DEVELOPMENT CONSENT AUTHORITY

AGENDA ITEM: **2** MEETING DATE: 16 September 2026 FILE: PA2026/0257

APPLICATION PURPOSE:	Dwellings-group (20 x 3 bedroom) in 7 x single storey buildings
SUBJECT SITE:	Section 6486 (23) Grice Crescent, Coolalinga, Hundred of Bagot
ZONE:	LMR (Low-Medium Density Residential)
SITE AREA:	5830m ²
APPLICANT	Mr Israel-Tshepo Kgosiemang (One Planning Consult)
PERSONS ON WHOSE BEHALF THE APPLICATION IS MADE	Maria Vordohilas (Director-Doxa Holdings Pty Ltd)
LANDOWNER	Doxa Holdings Pty Ltd
ANY PERSON WITH AN AGREEMENT TO ACQUIRE AN INTEREST IN THE LAND	None

Figure 2: easement details (Extract from the Survey plan (LTO20212/073A) and google maps)

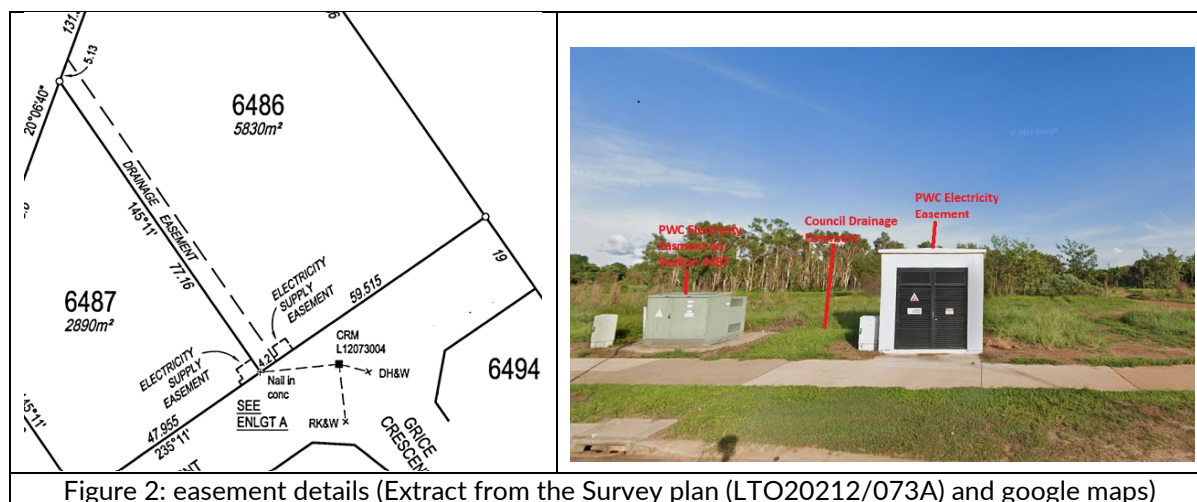
- The planting of shrubs or trees within the easement;
- Any landscaping other than grass or turf;
- Structures within the easement, including dividing fences, shade structures or canopies; and
- Fencing form that would restrict Council's access to the easement.

Council reviewed the applicant's response and maintained its position that no shrubs, trees or structures should be located within the easement area. Council further advised that landscaping within the easement should be limited to grass or turf and that any restrictions would need to be maintained for the life of the development.

As a result, the applicant cannot provide the landscaping outcomes for all dwellings ordinarily anticipated by Clause 5.2.6.1 as strict compliance with the landscaping requirement would be inconsistent with Council's requirements to protect existing drainage infrastructure and maintain unrestricted access for inspection, maintenance and repairs.

- a) Not include planting of shrubs or trees other than grass within yards of Units 1-9 affected by the drainage easement.
 - b) Demonstrate the use of pool fencing crossing the drainage easement located within Units 1 to 9 (this includes areas where the easement crosses external boundaries) and solid fencing along the property's western boundary.

Figure 4 – demonstration of buildings' encroachment towards boundaries

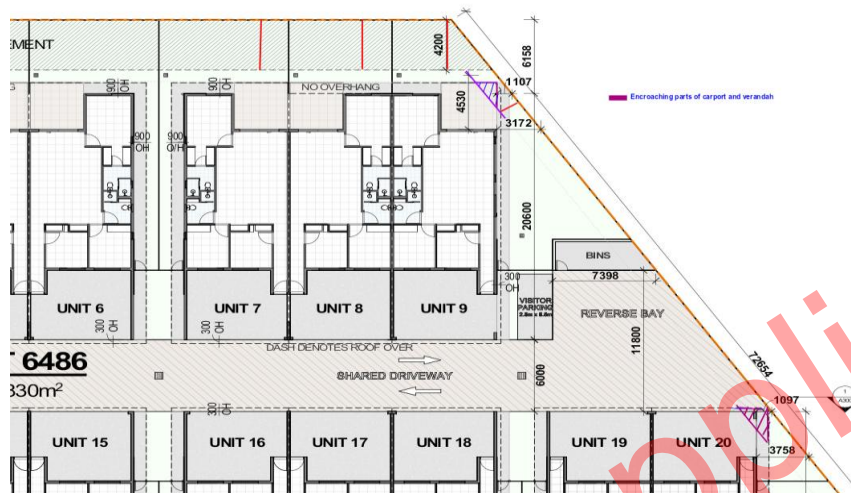
- The verandah and carport encroachments for Units 9 and 20 (see Figure 3 below) are minor and are unlikely to adversely affect perceived building mass when viewed from adjoining land.
- The proposal includes 1.8 m-high solid fencing along affected boundary sections to provide screening.
- The encroaching parts of the development have open elevations and thereby resulting in a diminishing effect when viewed from the neighbouring land.

Photograph 1 – Location of drainage easement looking from the street frontage

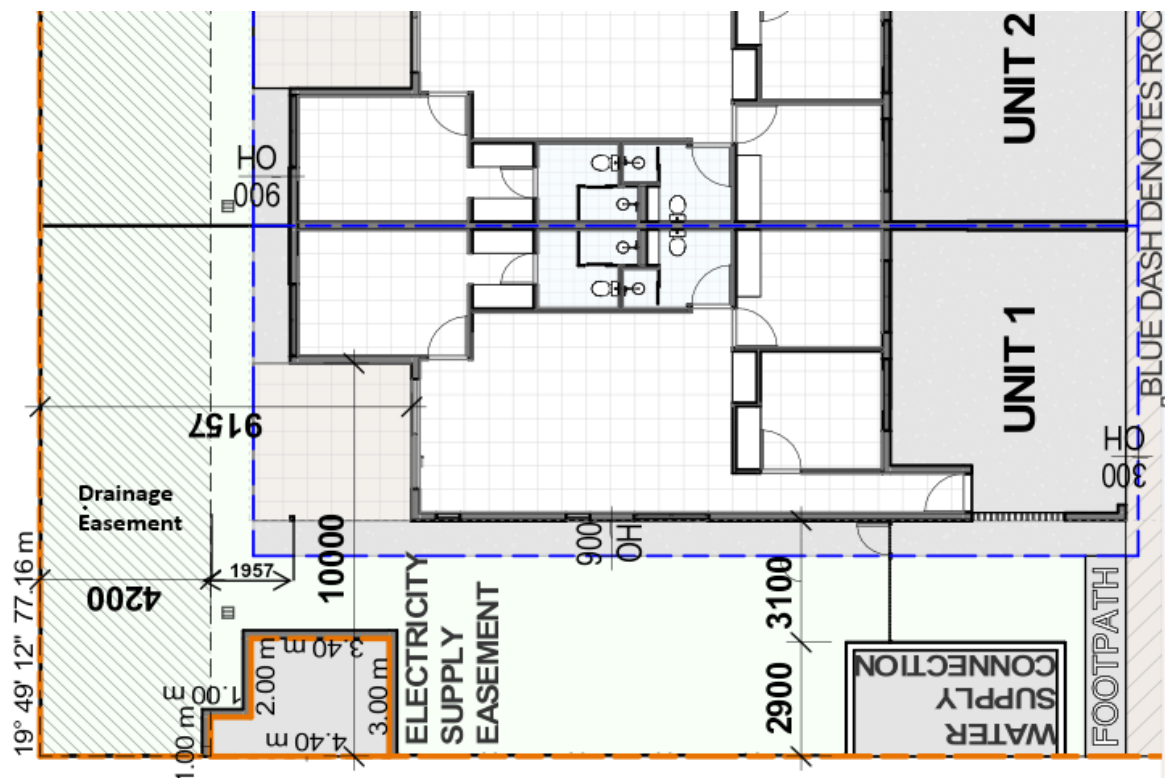
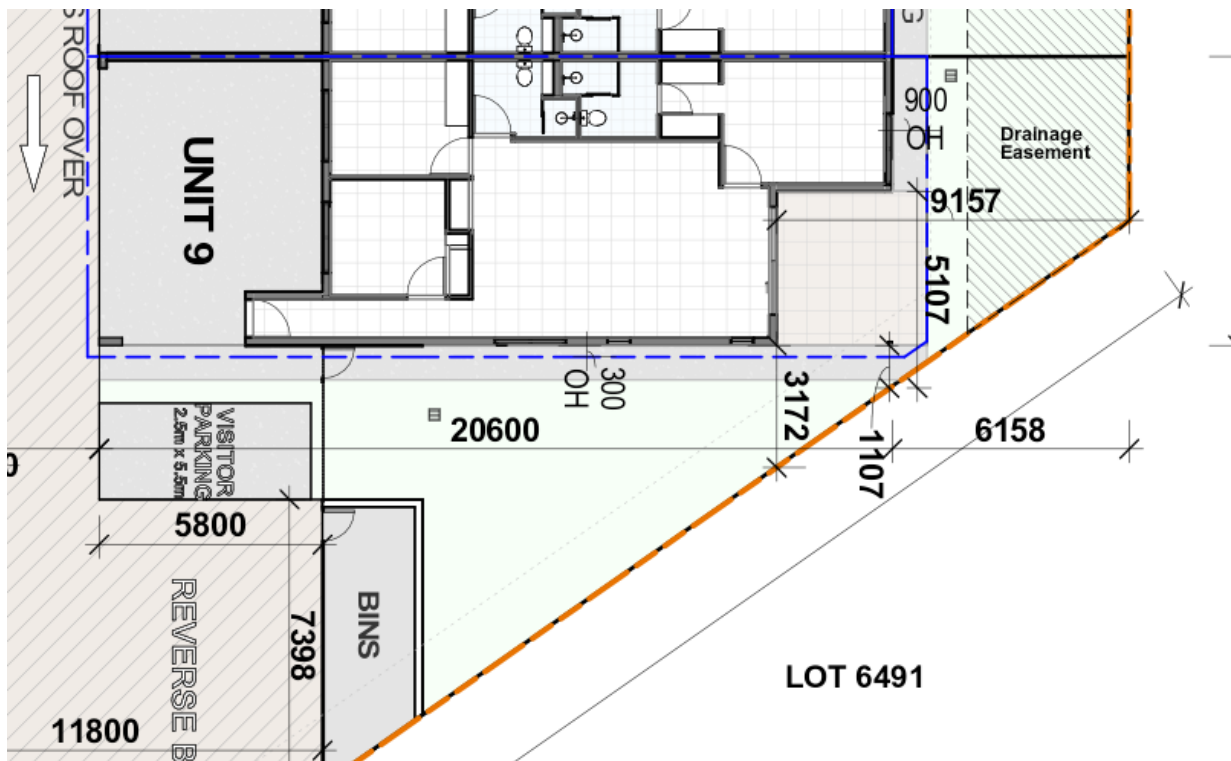
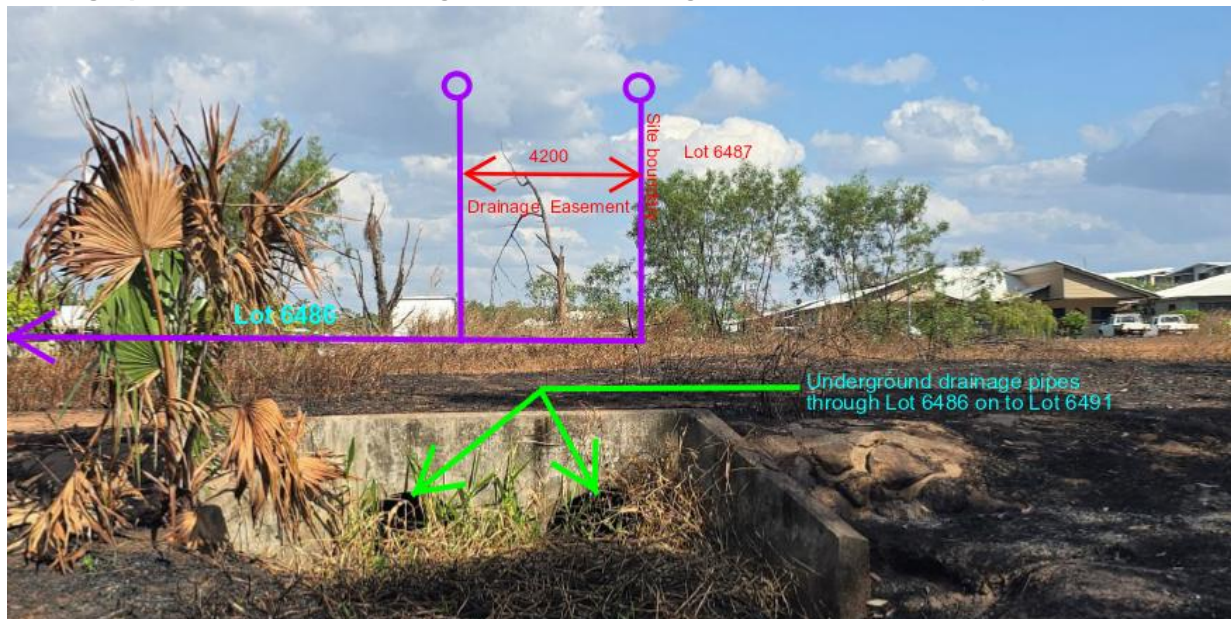
Following the site inspection, the photographs below show the stormwater easement and underground infrastructure crossing the property. The two large pipes discharge towards the swamp within Parcel 6491. This infrastructure forms part of the local stormwater management network established as part of the Coolalinga subdivision.

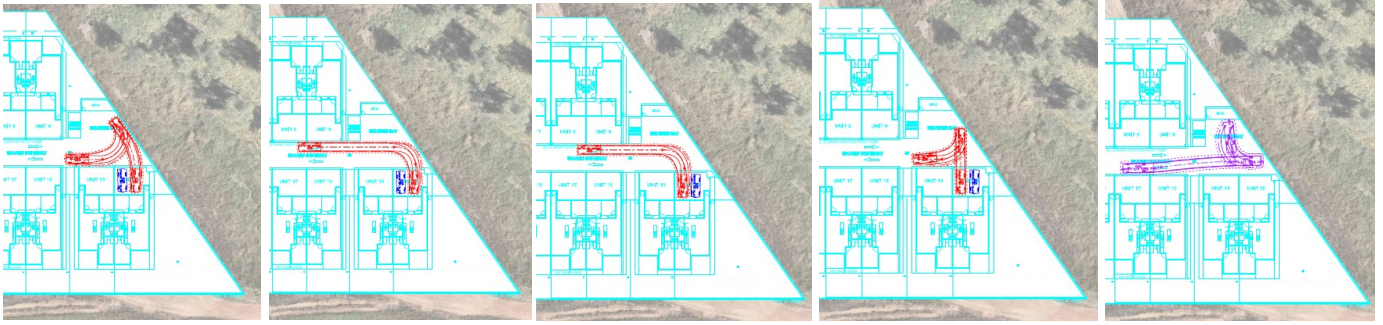
The provided swept-path diagram illustrates the two parking spaces for unit 19 and 20 will need to reverse approximately 9m into a turning bay before undertaking a three-point turn to exist in a forward gear. The design is considered generally to comply with the requirements including being functional and allowing vehicles to enter and exist to the road in a forward gear.

The car parking spaces are in accordance with the minimum dimensions with the parks having a width of 5.2m and a length of 5.8m. The driveway has a width of 6m, which allows for two-way traffic flow. It also maximises sight lines for drivers entering and existing the car parking area.

Figure: extract from submitted plans

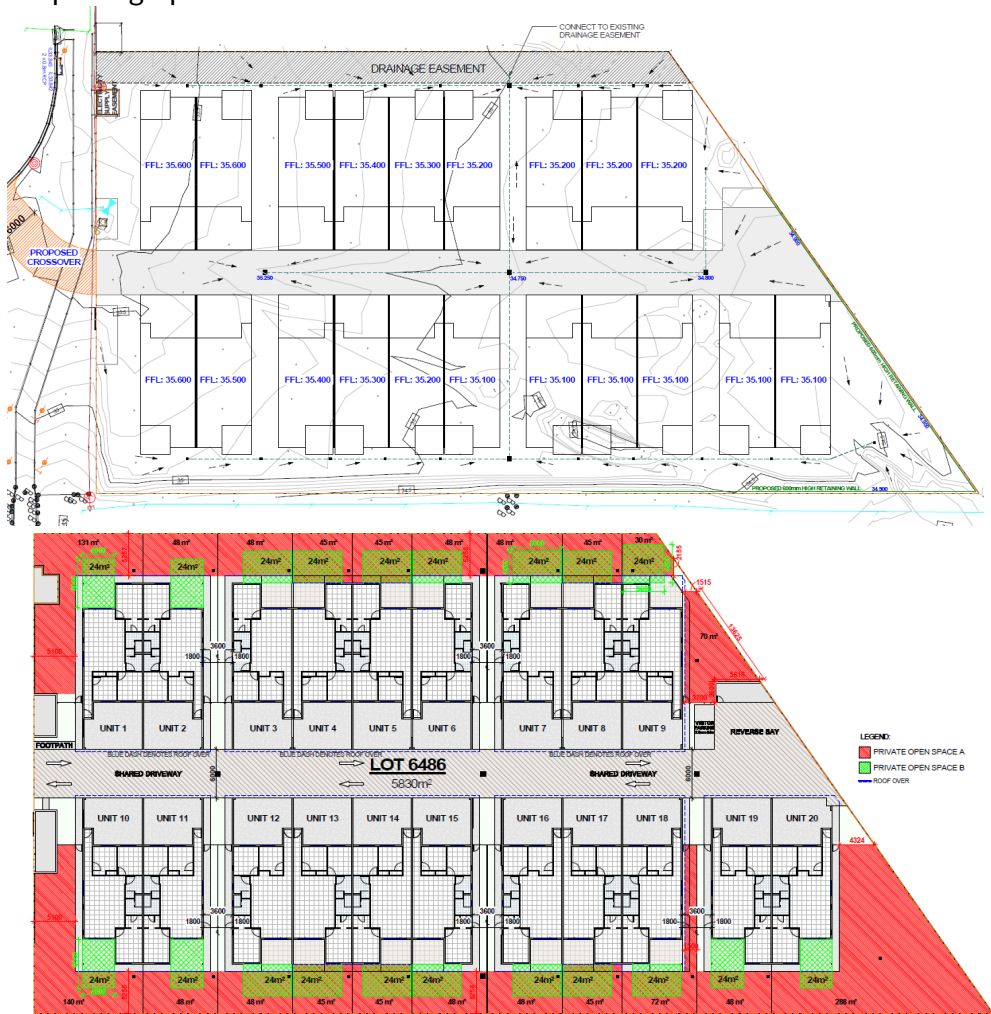
Furthermore, Unit 1-9 are partially constrained by drainage easement registered on Land title (and associated drain / gradient / Council infrastructure) –Proposed and existing gradient / functionality of private open space area Shown on drawings- storm water (overland flow) passes through Unit 6-7 into Council inlet – see photograph below.
